STATE OF TENNESSEE  
**DEPARTMENT OF ENVIRONMENT AND CONSERVATION**  
3<sup>rd</sup> Floor, L & C Annex  
401 Church Street  
Nashville, TN 37243-1532

This is a follow-up to our letter to you dated March 29, 2004, concerning vibration testing performed for the Berthold Technologies, U.S.A., LLC Model LB 7400 Series. After further review, including applicable NRC registrations, we now realize that there is no ANSI or NRC standard test for device vibration.

With reference to your recent letter dated April 23, 2004 about our vibration test reports I would like to further clarify and define the previous correspondence and statements.

FIGURE 1—Amplitude of vibration at resonance frequency.

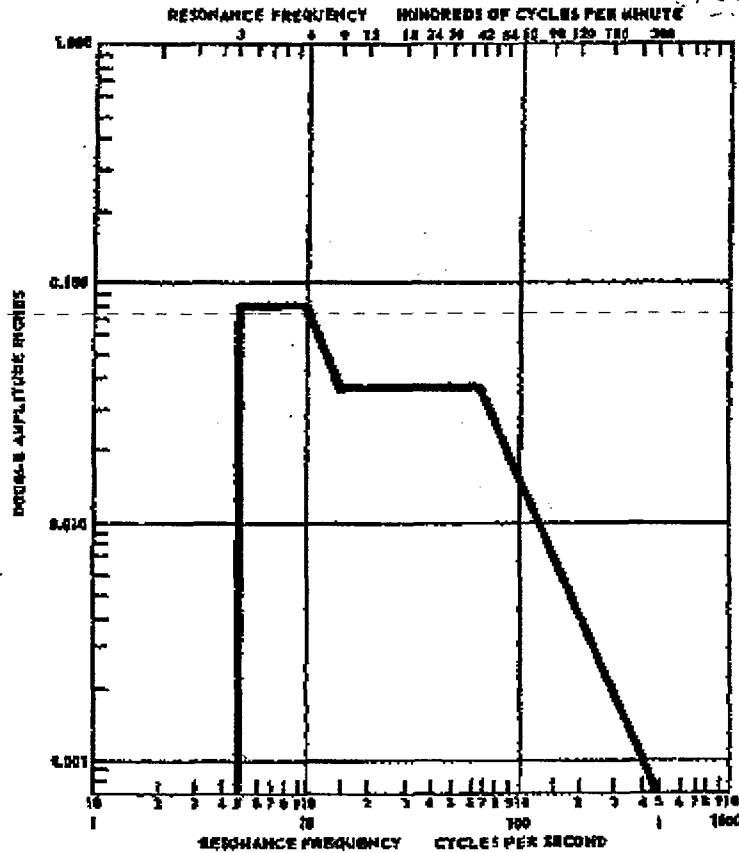
For backup information, please note the attached letter dated April 26, 2004, from Berthold in which they use 32.101 B as a comparable framework for the tests. They chose a double amplitude of 1 inch which is much greater than that in Figure 1.

We will propose that the limitations of vibration not exceed 200 Hz with the corresponding double amplitudes in Figure 1. **Would the NRC concur with this limitation?**
